S12226 - Telopea Masterplan

DRAWING LIST

TELOPEA RTS 2 S4.55 SCHEDULE OF DESIGN CHANGES

Telopea RTS 4 S4.55 Schedule of Design Changes (December 2023)

Masterplan
Core & East Precincts - Lot
Subdivision plan

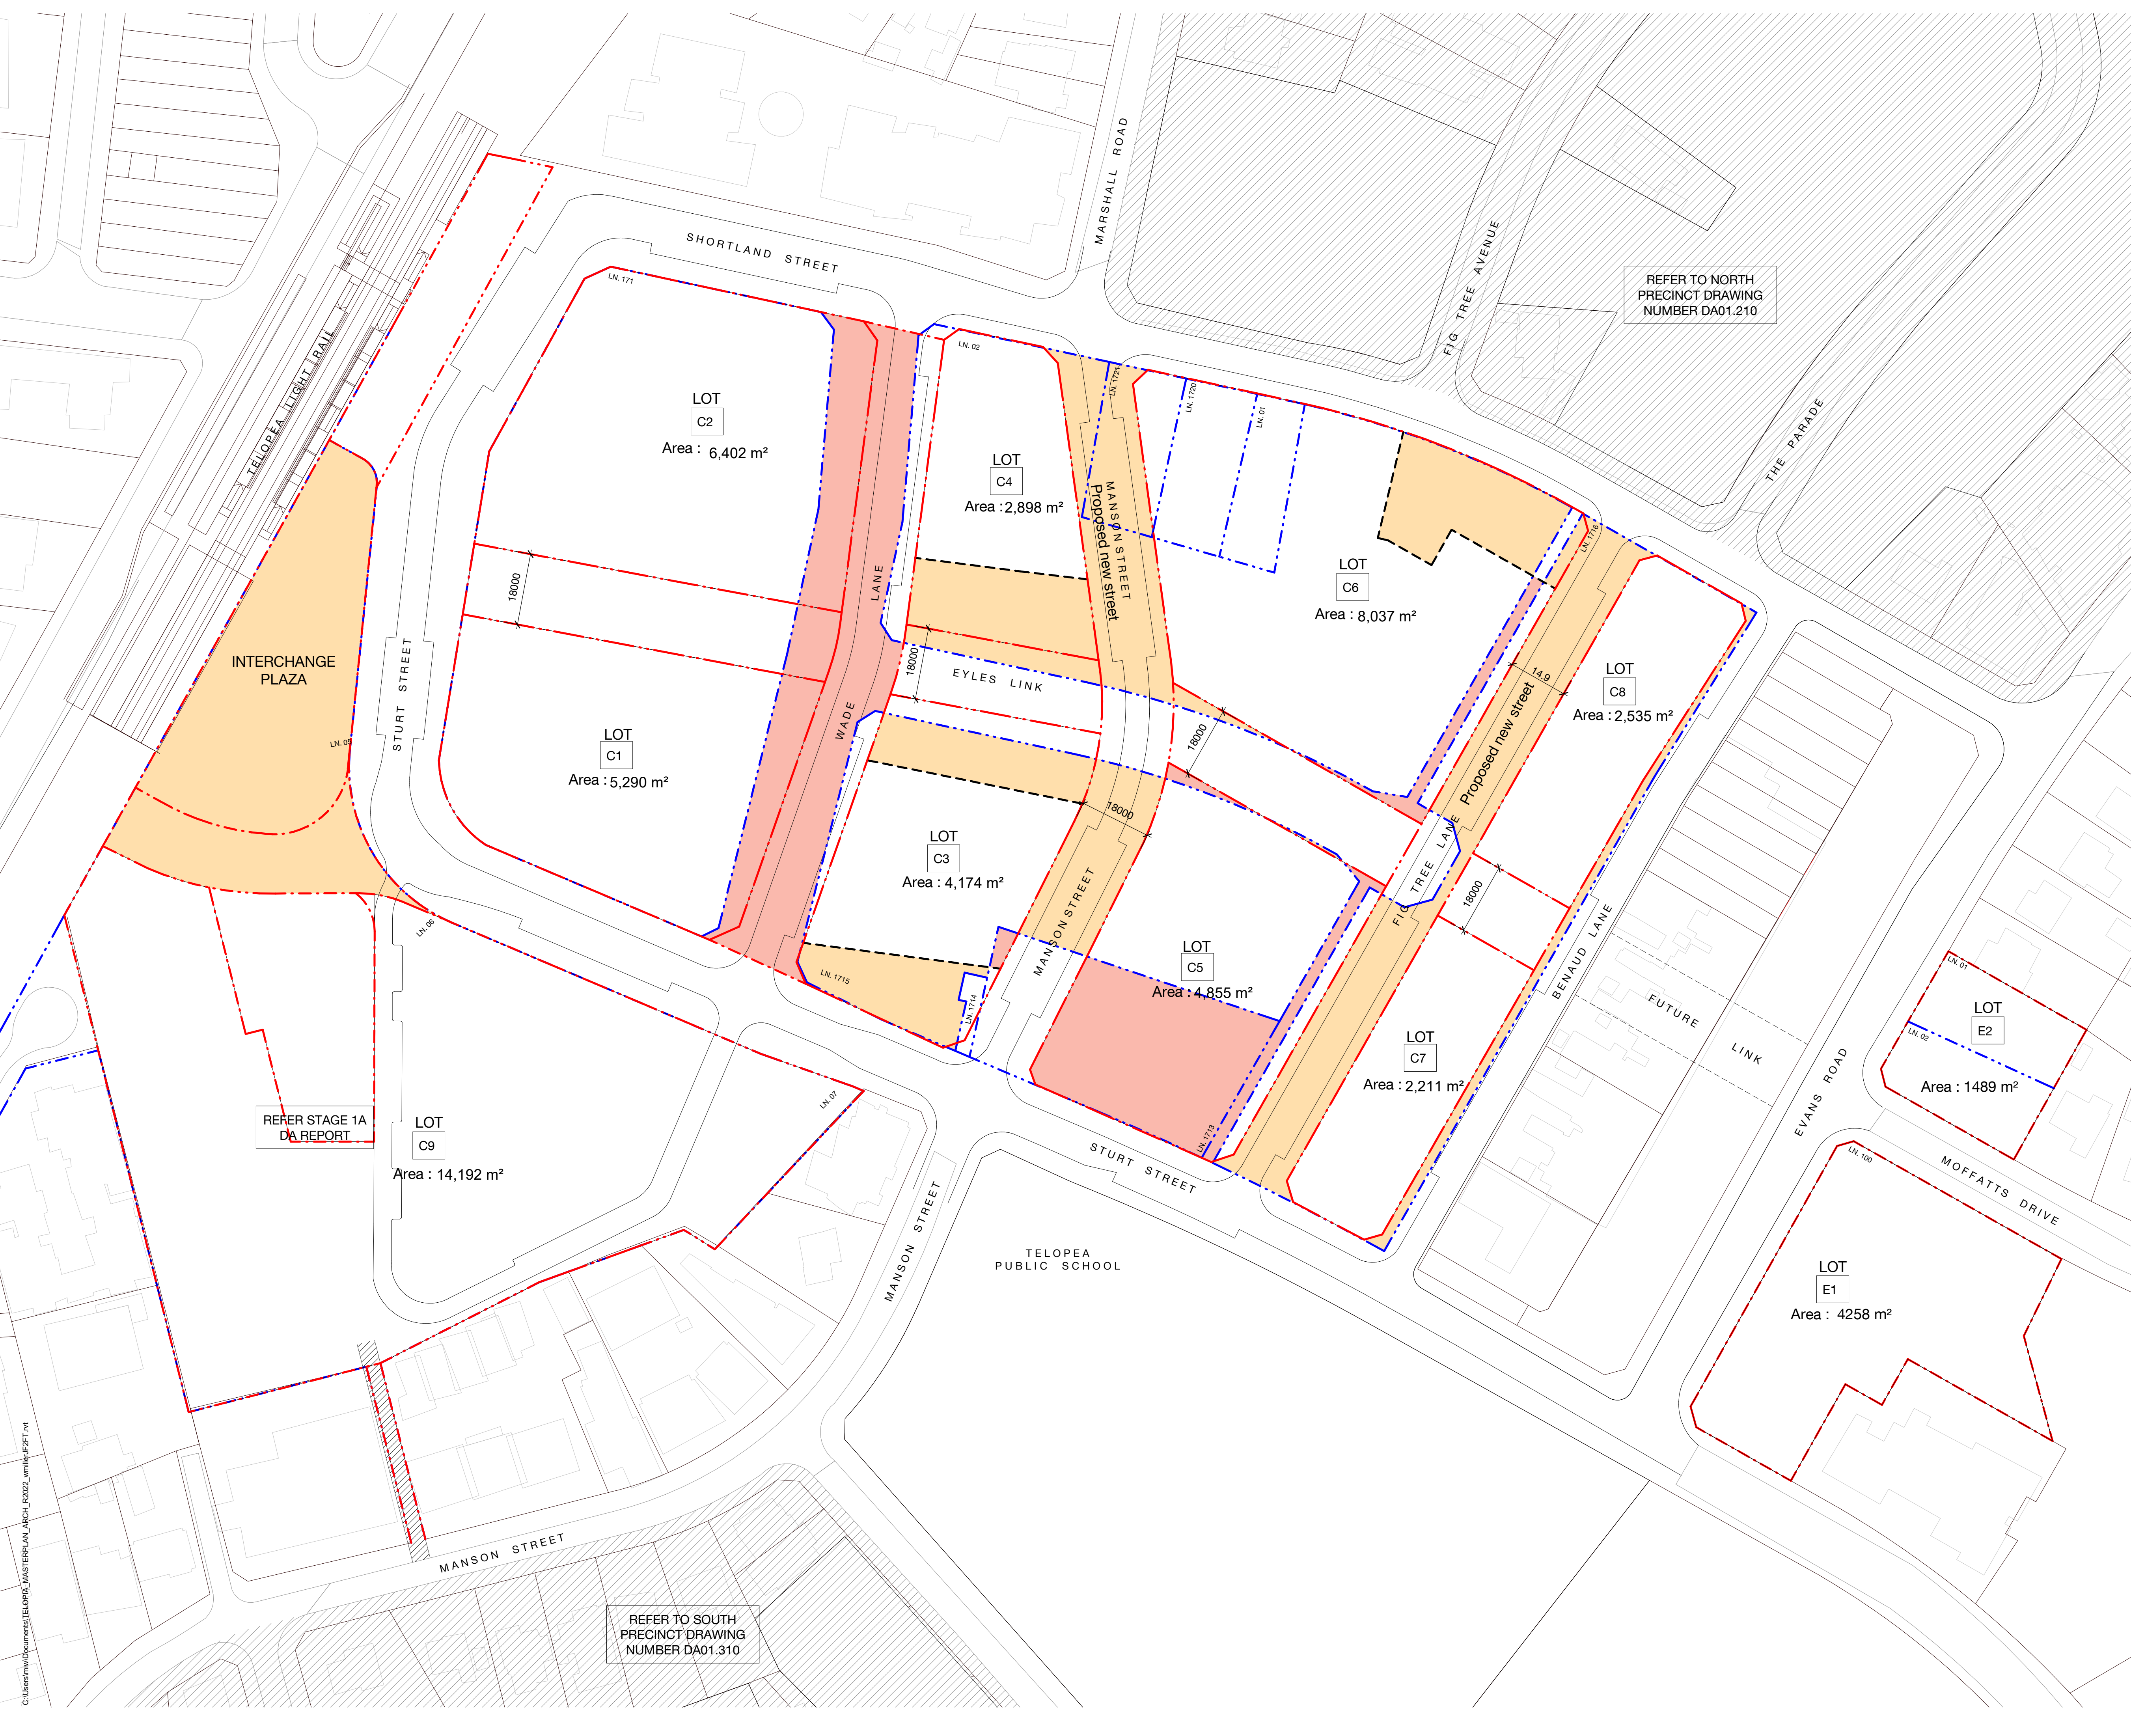
6. Lot subdivision and deep soil plan updated to remove land transfer to Eyles link between C7 and C8
- North Precinct
7. Rear setbacks increased from 6m to 9m above 16m to lots N8, N9 and N10, refer to envelopes DA01.MP.230[6] and DA03.MP.500[1]
- South Precinct
8. S5 Rear setbacks increased from 6m to 9m to comply with adjacent r3 zone requirements and improve transition in scale to neighbouring developments. Refer DA03.MP.500[1]

**Masterplan
Core & East Precincts - Deep Soil
Areas**

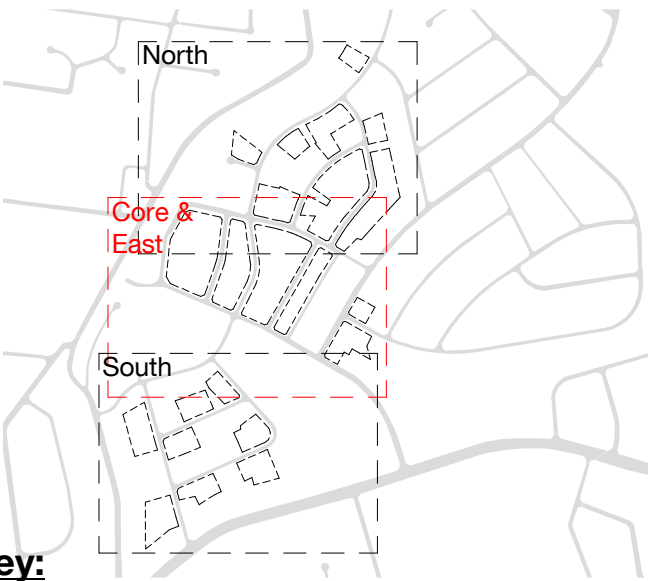
16. Deep soil increased from 25% to 30%

24. Deep soil increased from 25% to 30%
